LOQ-10-20.19
RECONSTRUCTION OF EXISTING SEPARATED
CROSSING WITH N.Y.C. R.R.
LORAIN COUNTY
RIDGEVILLE TOWNSHIP

TITLE SHEET	1
TYPICAL SECTION	2
CALCULATIONS-GENERAL NOTES-TABLES-GENERAL SUMMARY	3
PLAN & PROFILE	4-8
CROSS SECTIONS	9-17
BEFORE ROAD APPROACH & SIDE ROAD CULVERT	18
CULVERT & OUTLET STORM SEWERS	19
STRUCTURES OVER 20' SPAN	20-27
RAILROAD FORCE ACCOUNT WORK	28
CHANGE ORDER N° 2 (ADDED TO PLAN 12-8-52) KT	28-A, B, C.

LOR.-10-20.19
CHANGE ORDER No. 2

LOR-10-2019
CHANGE ORDER No. 2

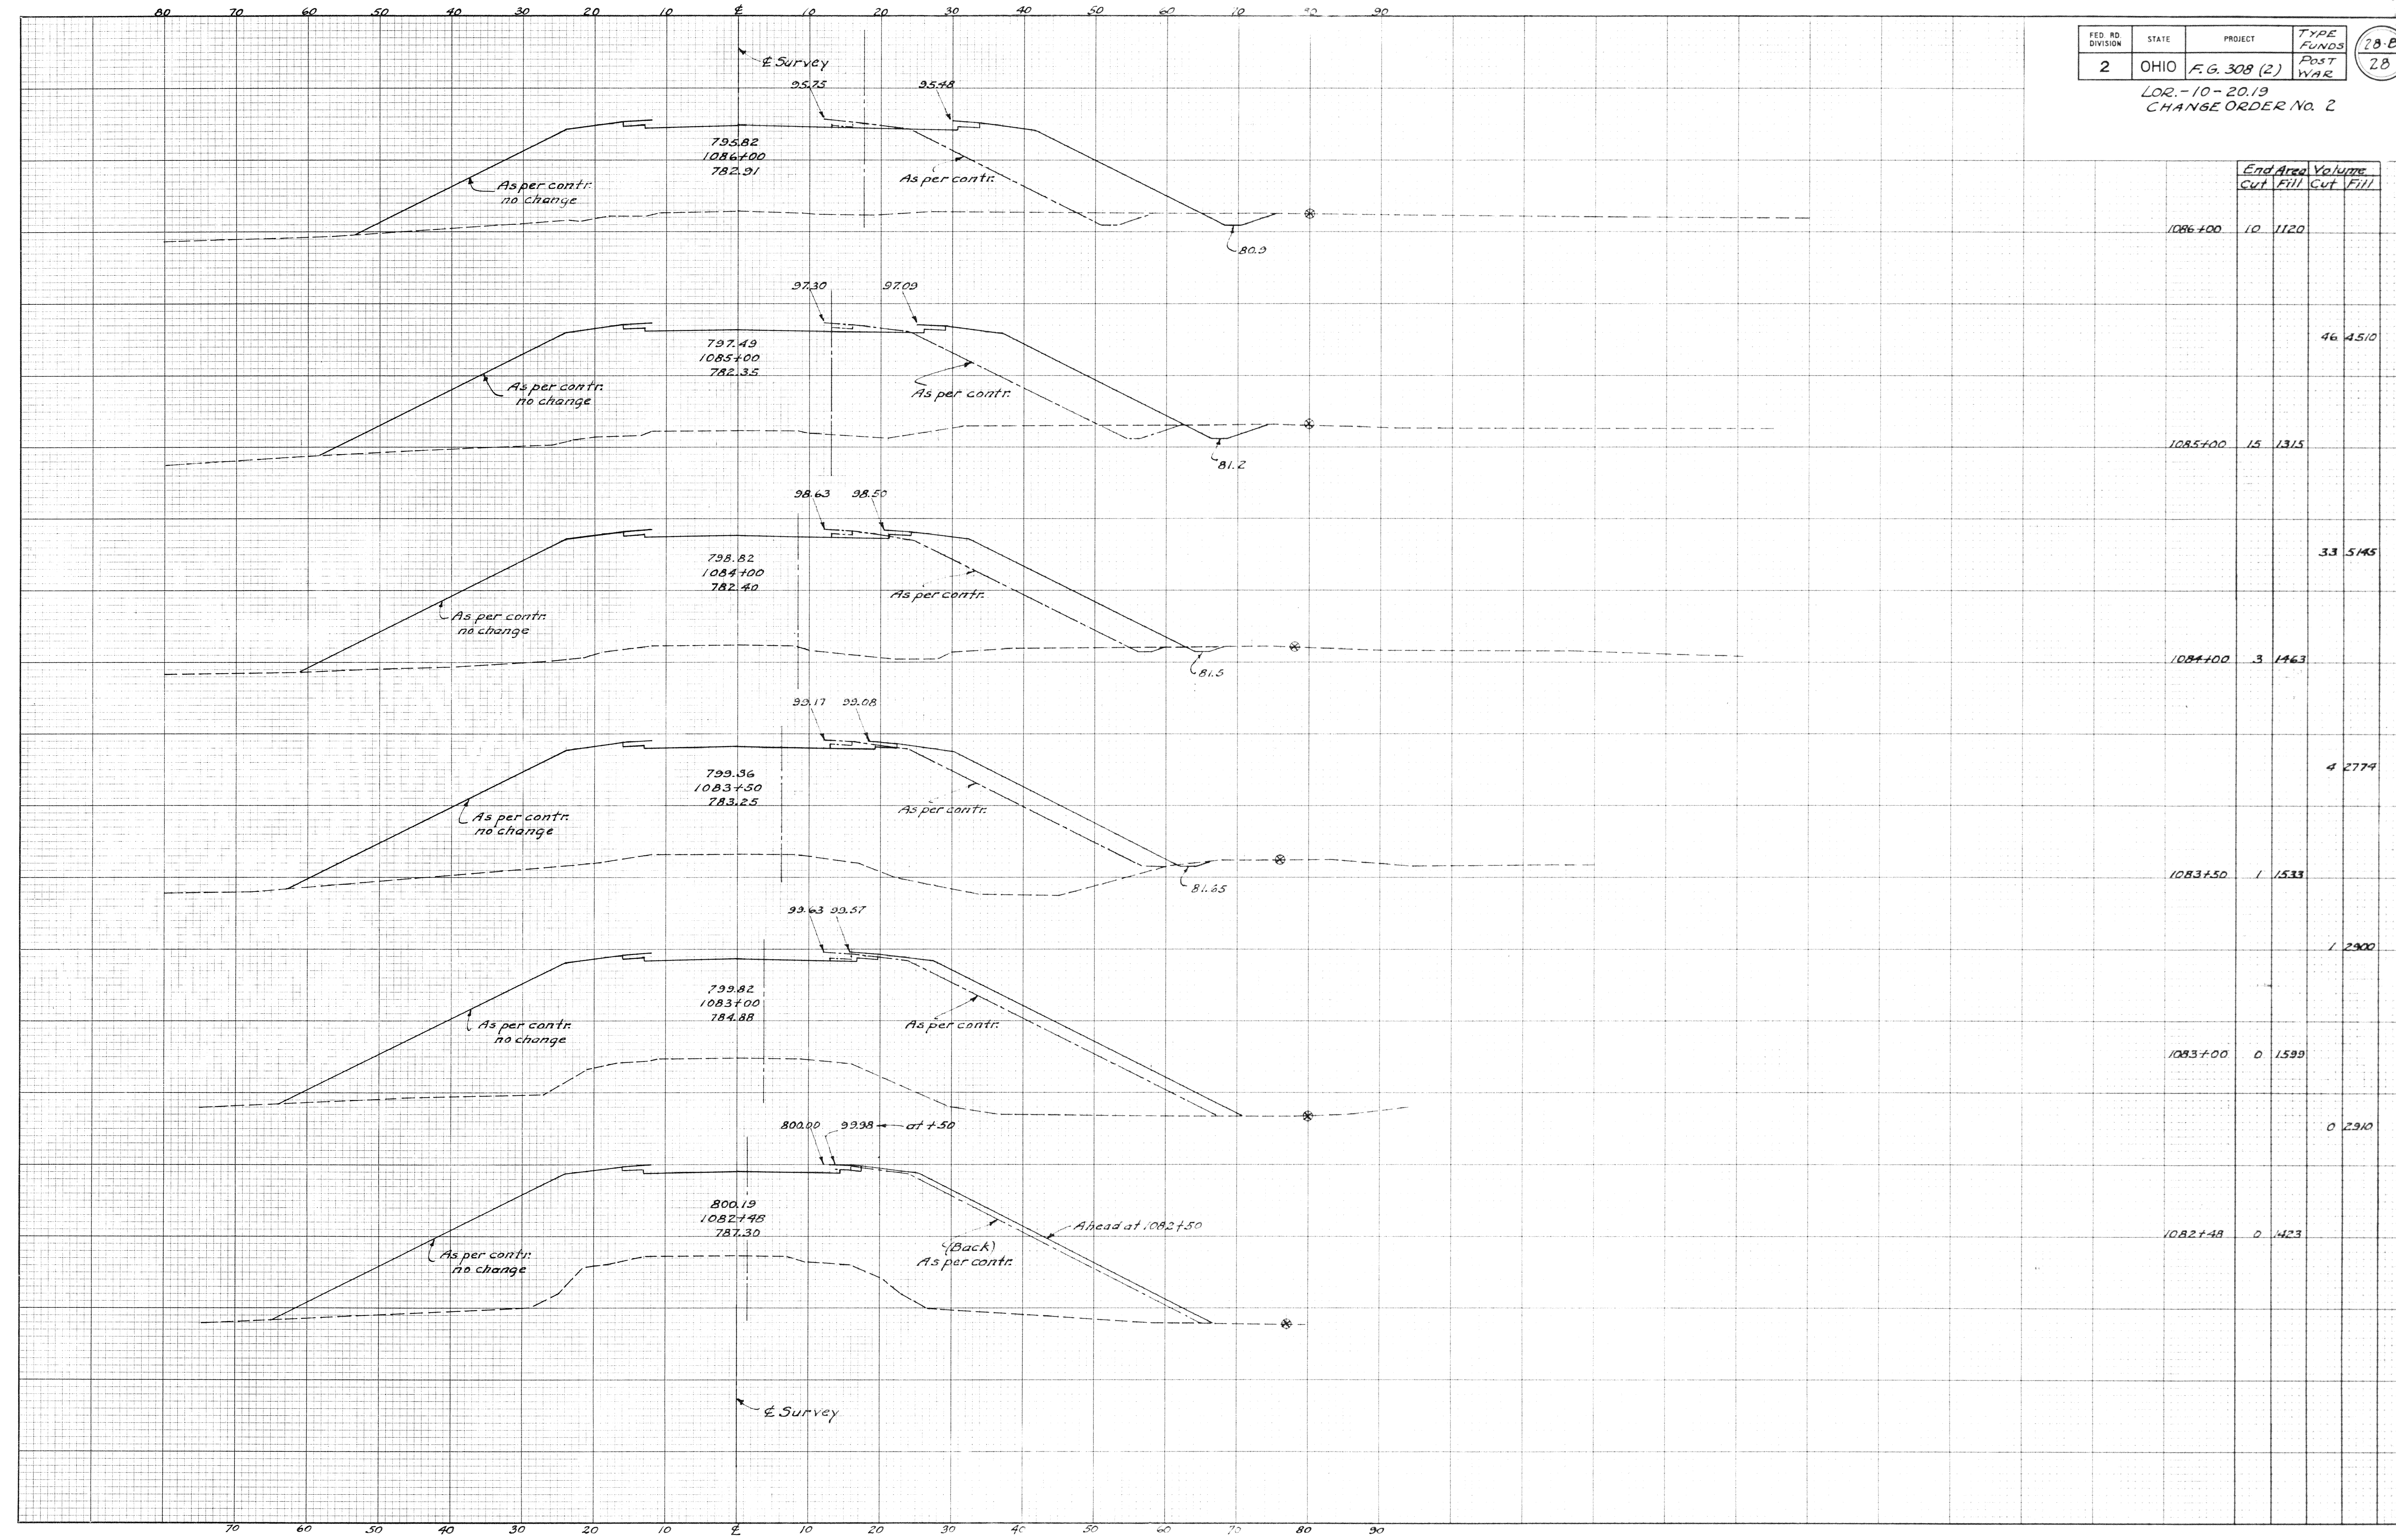
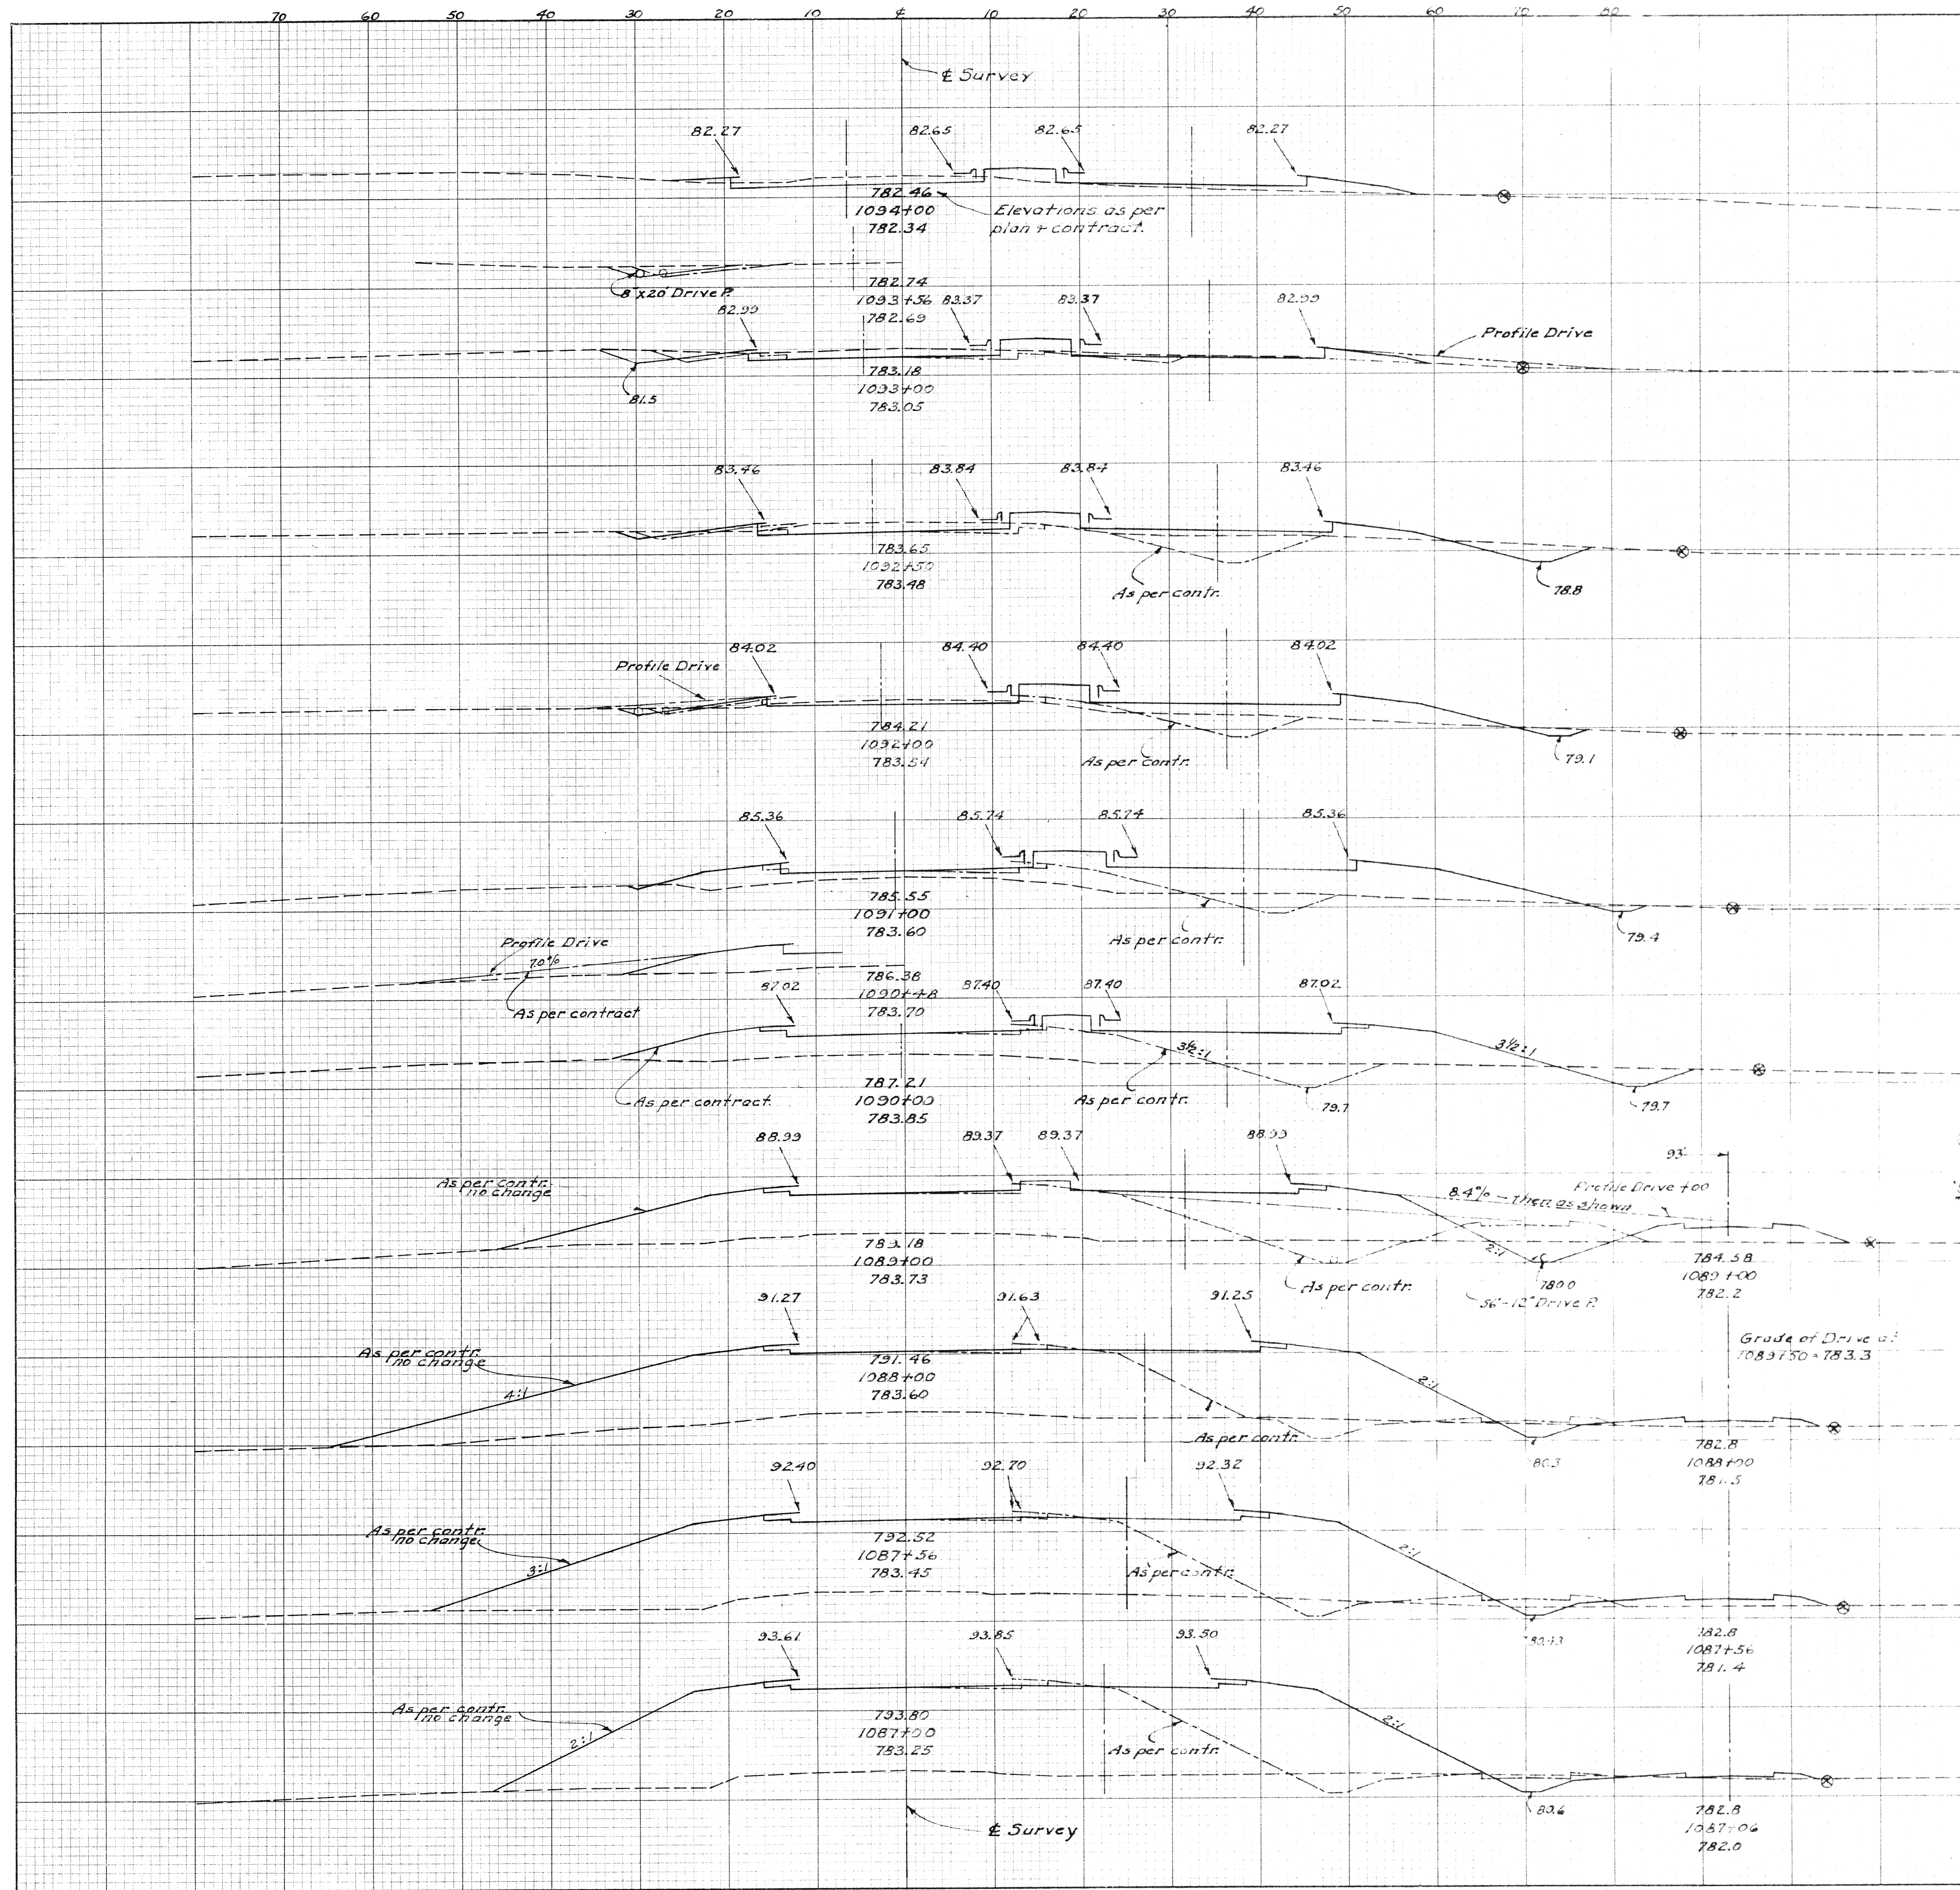
Notes
The 8"x20" Drive Pipe at Sta 1094+44 on Lt. to be non-performed.
The 8"x20" Drive Pipe at Sta 1093+56 and the 8"x20" Drive Pipe at Sta 1092+16.5 may or may not be non-performed depending upon the date of Turnpike Construction.
